PIMA COUNTY FLOODPLAIN USE PERMIT APPLICATION

DESCRIPTION OF WORK (A site plan DRAWN TO SCALE and showing ALL proposed work must be attached)
 ROADWAY ACCESS THROUGH DAVIDSON CANYON WASH TO MINERAL LEASE. ACCESS ROAD WOULD BE 50ft WIDE.

CALIFORNIA PORTLAND CEMENT
 HAUL ROAD GRADING PLAN
 THROUGH DESIGNATED RIPARIAN LIMITS
 FOR
 DAVIDSON CANYON

Davidson Canyon FPUP Comment Response

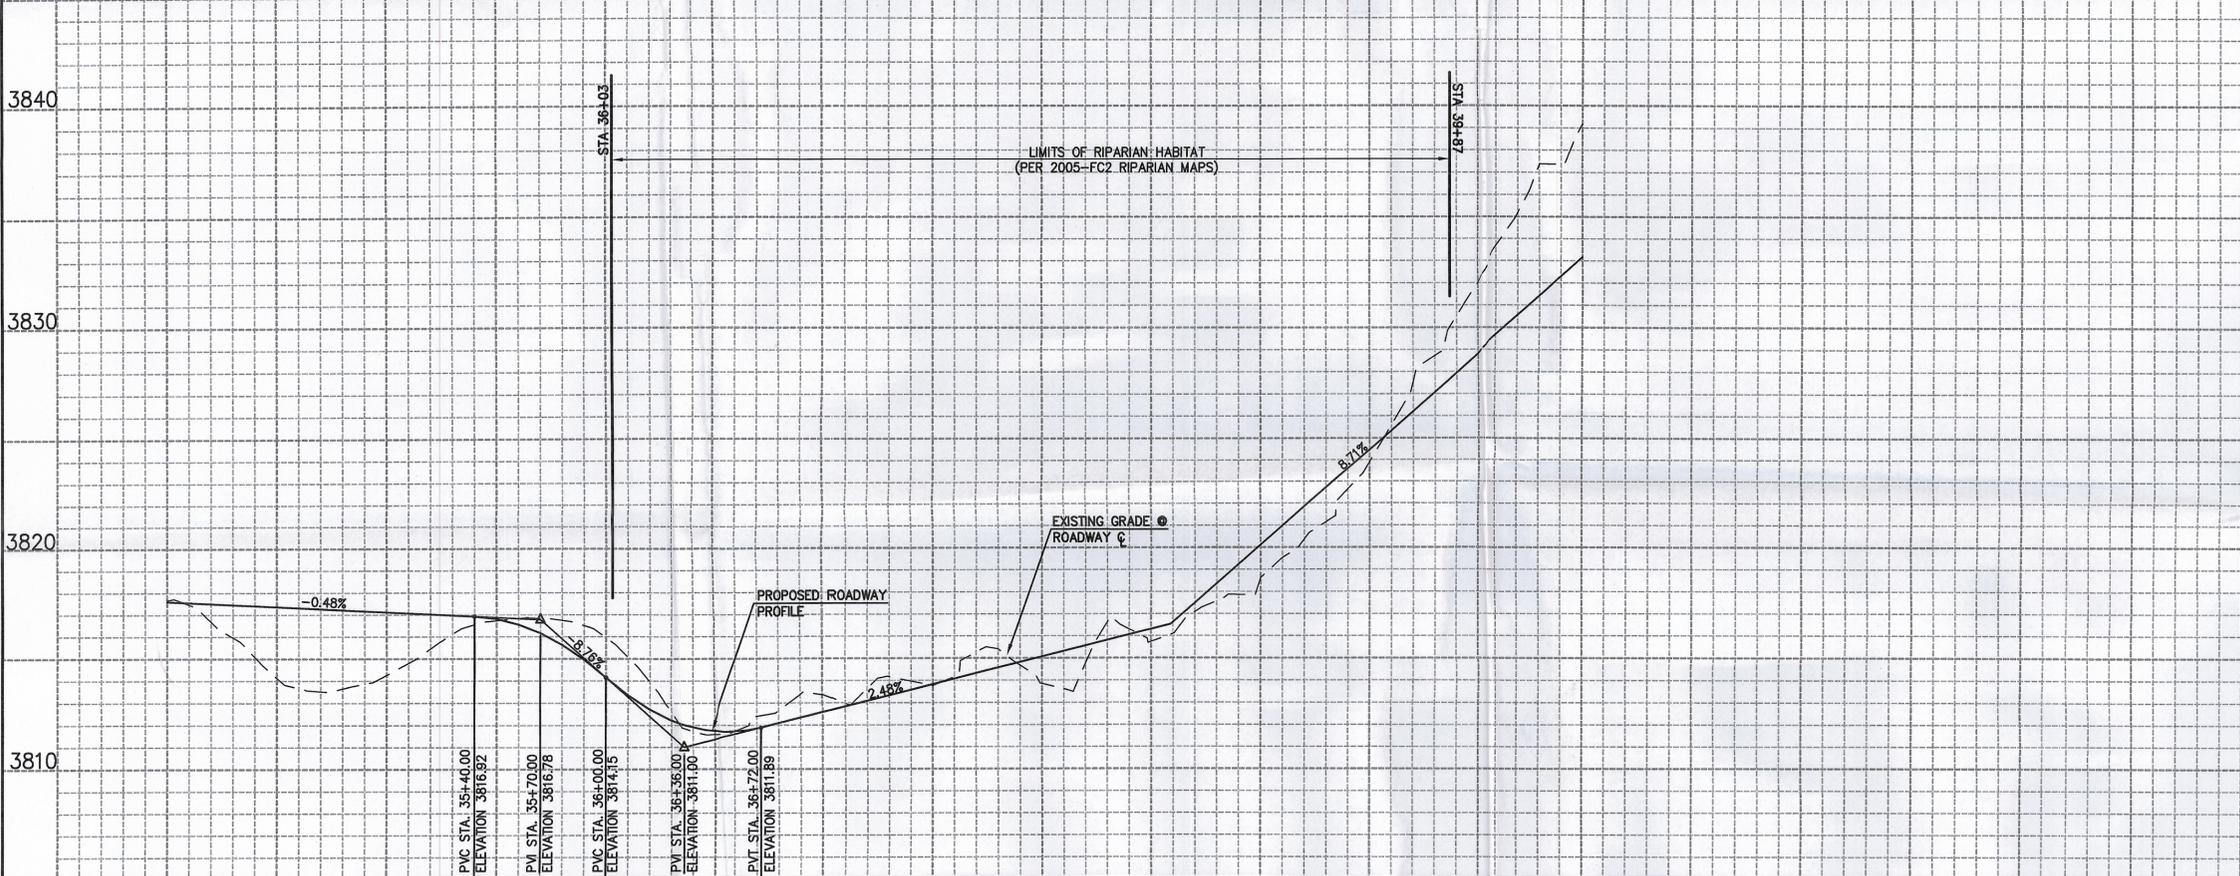
The attempts to drive the stakes and rebar into the proposed haul road were offset from the centerline station marker to account for the roadway width and fill slopes. Soil conditions varied greatly throughout the site. At many locations, the ground consisted of solid rock at both the inverts of existing channels, and at the top of hills. Gravel varying in size from diameters less than one inch to diameters of several inches was apparent at the surface as well as under the surface throughout the site. The presence of this larger gravel under the surface often prevented the stakes and rebar from reaching the minimum depth of 12" required for installation of hay bales and silt fence. Several of the stations were also located in washes or

canyon inverts, where the soils is considerably loose and allows for the stake to be easily inserted to the required depth.

As can be seen in the summary table, and throughout the photo journal, the conditions of the site vary throughout the project limits. While there are sections of the proposed roadway that silt fence and or hay bales can be installed properly, there are also many sections where it cannot. The exact locations everywhere along the roadway where silt fence and hay bales can be used is unknown, but can be estimated from the site investigation. Where determined in the field that those BMPs cannot be used another suitable method must be selected. Such methods could include, but are not limited to, a sediment control berm, hydroseeding and mulching, soil roughening and gravel bag berms. These methods may be used as the primary methods of erosion control, and may be easier to install and maintain than silt fence and hay bales. Specific methods of stabilization and sediment control shall be defined in the SWPPP for the project.

Enclosure *Map of the limit of riparian area*

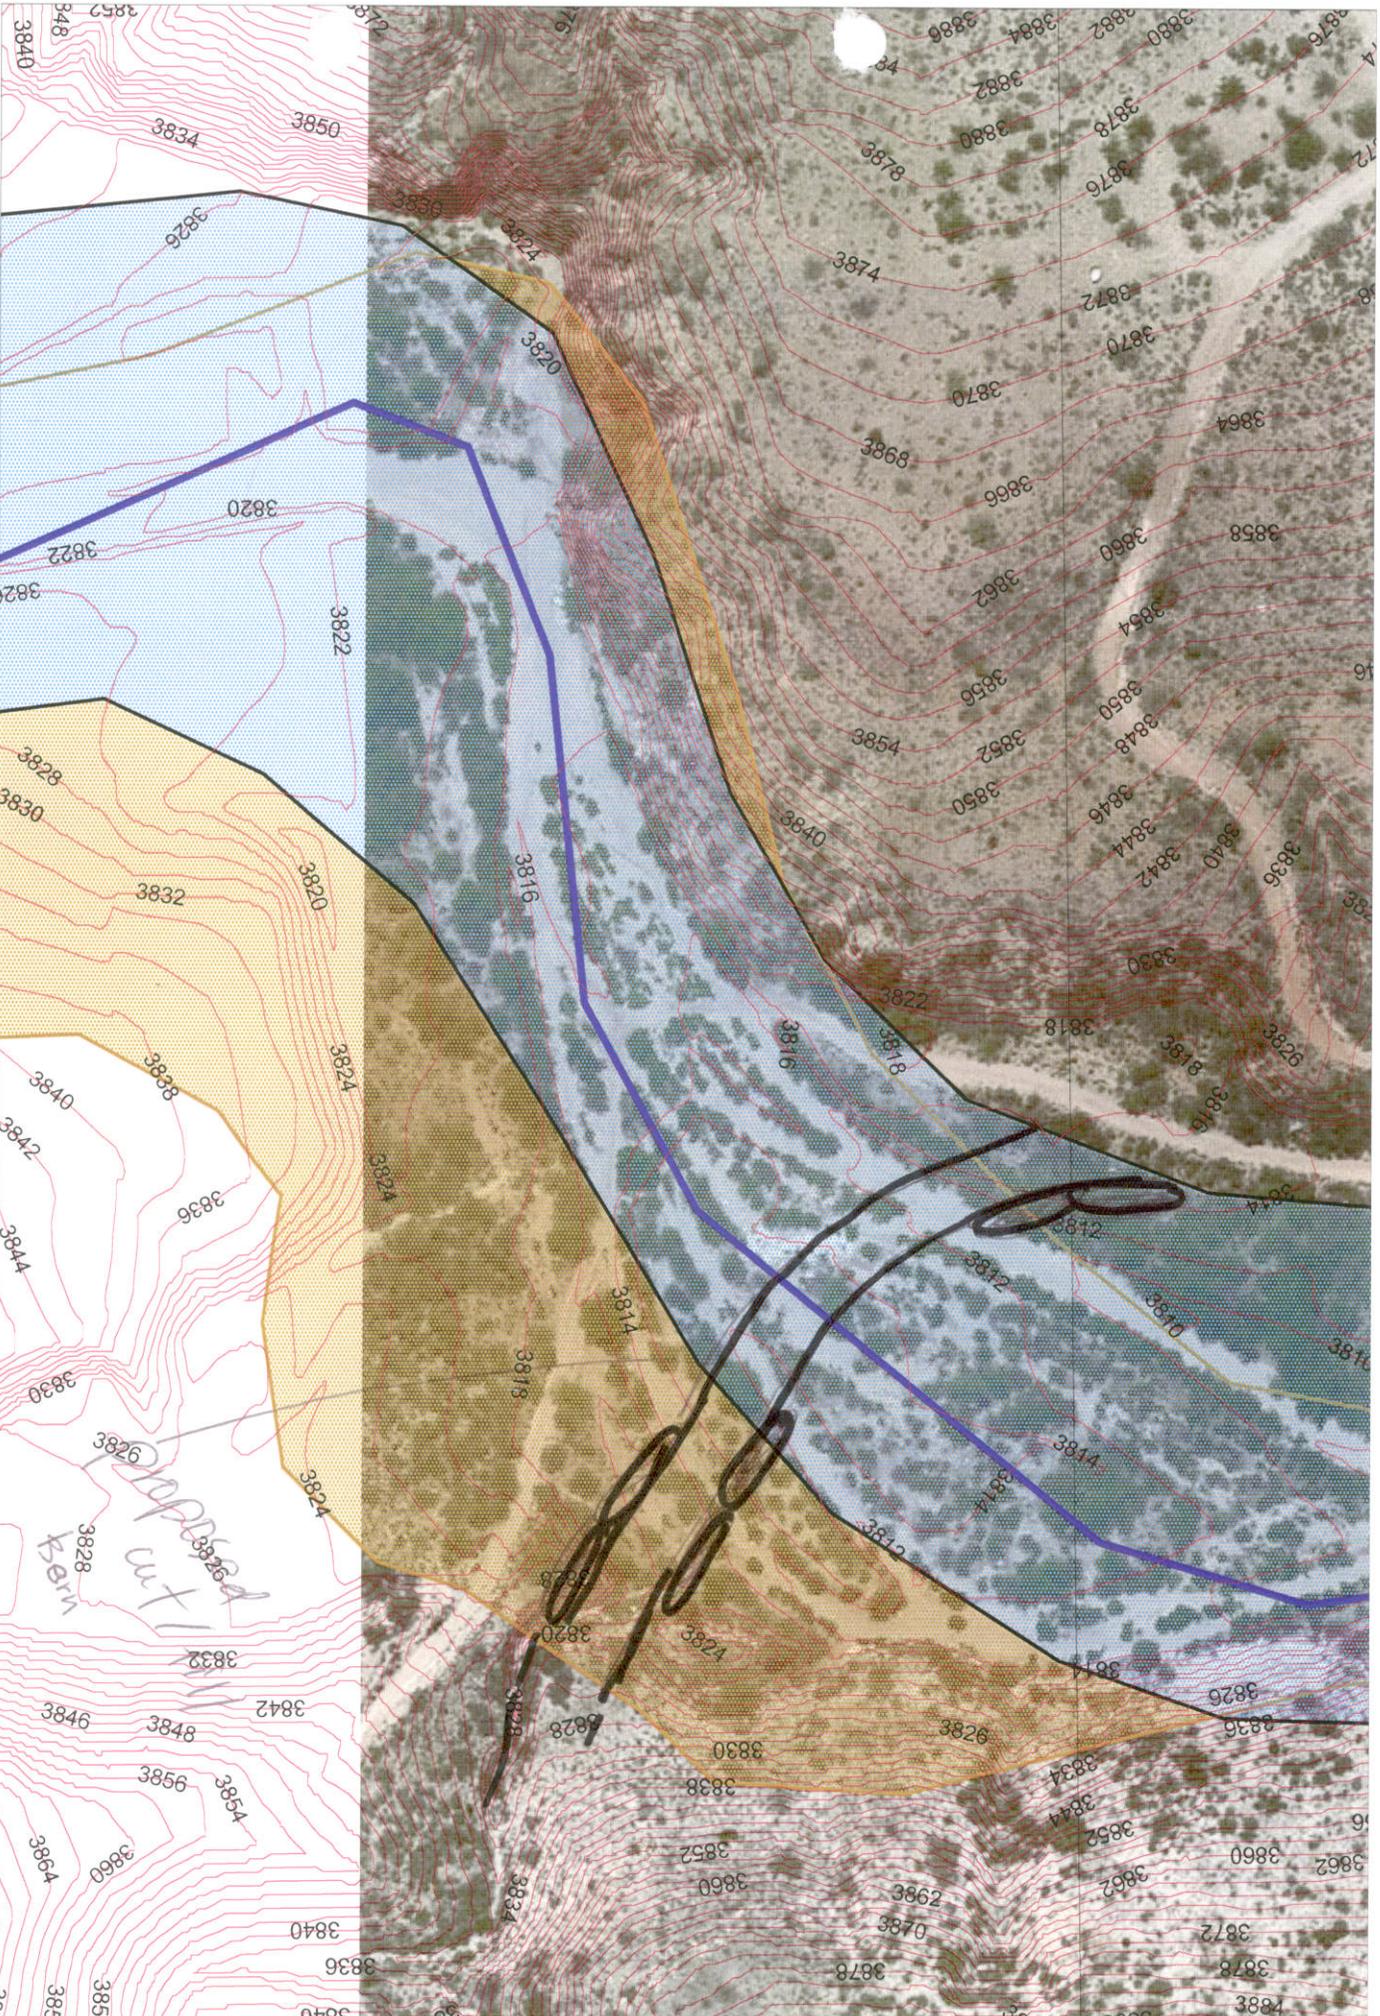
- 1) The subject property contains mapped Important Riparian Habitat. In accordance with Chapter 16.30.040 of the Ordinance, when the disturbance of more than 1/3 acre of mapped Riparian Habitat is proposed, a Habitat Mitigation Plan is required and must be approved by the District. It appears that the site plan does not accurately reflect the riparian limit. The riparian habitat limits, as shown on the site plan shall be shifted 130 feet to the north to align accurately with the 2005-FC2 riparian habitat maps and the on-site riparian habitat. Please recalculate the disturbance of the riparian habitat once the riparian habitat limits have been shifted, and place a total disturbance calculation on a new site plan. Please be advised that previous disturbance, prior to mapping of the riparian area is not to be included in the calculation of new disturbance (please see the enclosed map).

- 2) The submitted site plan is too small to determine the disturbance of the riparian area. In addition, in accordance with Section 16.42.010 of the Ordinance, the Grading Design Manual, prepared pursuant to Chapter 18.81 of the zoning code shall be used to prepare proposed works. Please provide a larger map to show all the proposed activities (excavation, road construction, structural and non-structural control works, equipment staging area construction, etc.) using the Grading Design Manual. Please be advised that grading limits, topography, wash line, the watershed boundaries for all the basins (West Quarry Basin, East Quarry Basin, and so on), and riparian habitat limits to be shown on a modified plan.

The riparian limits have been shifted to accurately represent those shown on the effective County riparian habitat maps. The actual area of disturbance based on the proposed grading limits from the haul road grading plan has been recalculated as 0.297 acres.

Photo 62 – Disturbed hillslope that has not recovered to pre-disturbance conditions.

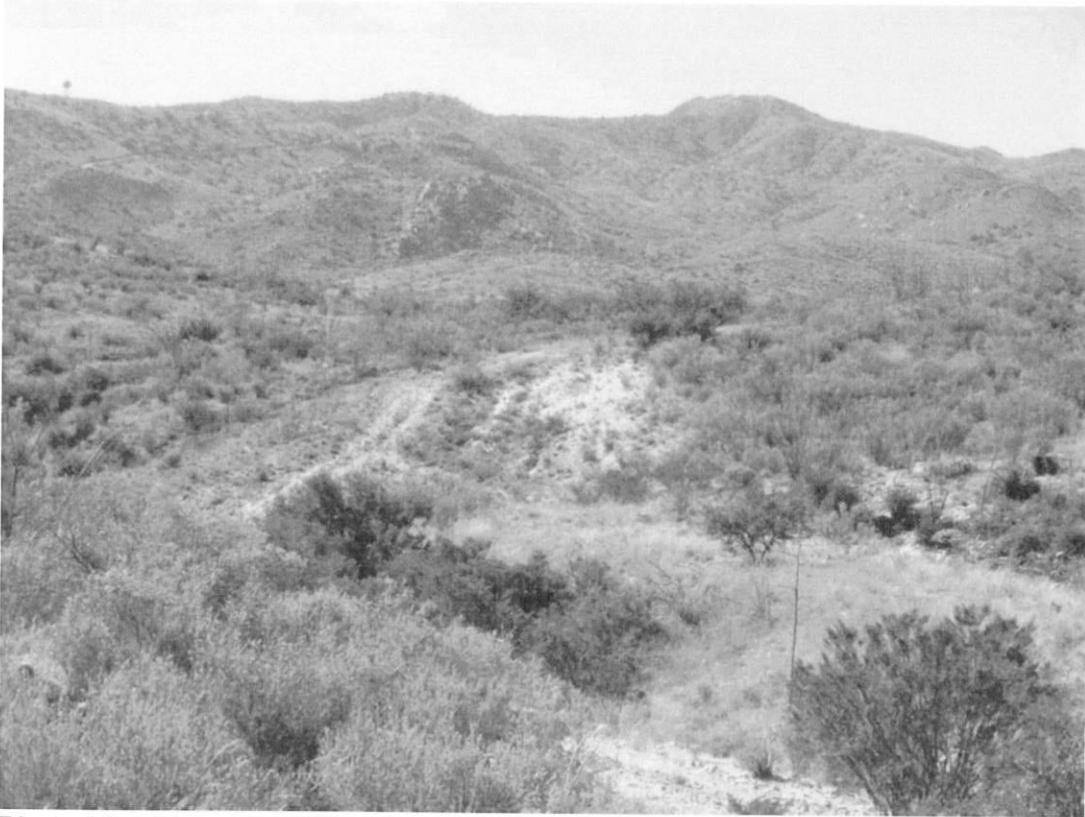
Where hillsides have previously been disturbed, vegetation has not recovered to previous conditions (photo 62).

Therefore any disturbance of the upland has the potential to destabilize the thin soil resulting in a degraded hillside that will not recover to current conditions.

Photo 72 – Incised drainage into Davidson Canyon.

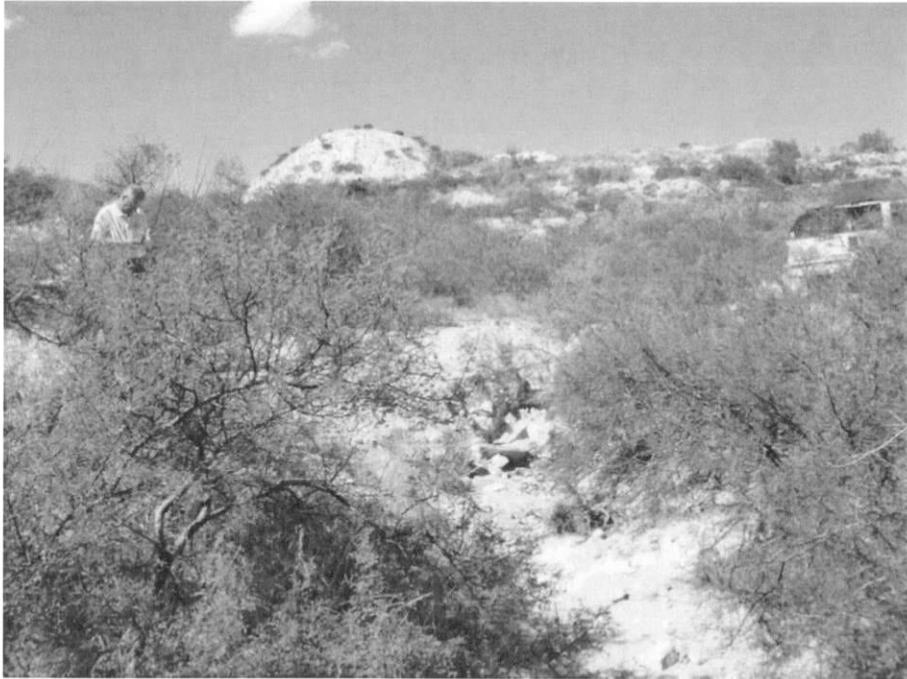
3.) Well-defined drainages on the Western Lease plots that drain directly into Davidson Canyon. Steep drainages on the Western Leases (16 & 17) dissect the proposed lease properties resulting in potential to deliver any eroded materials and mine spoils directly to Davidson Creek.
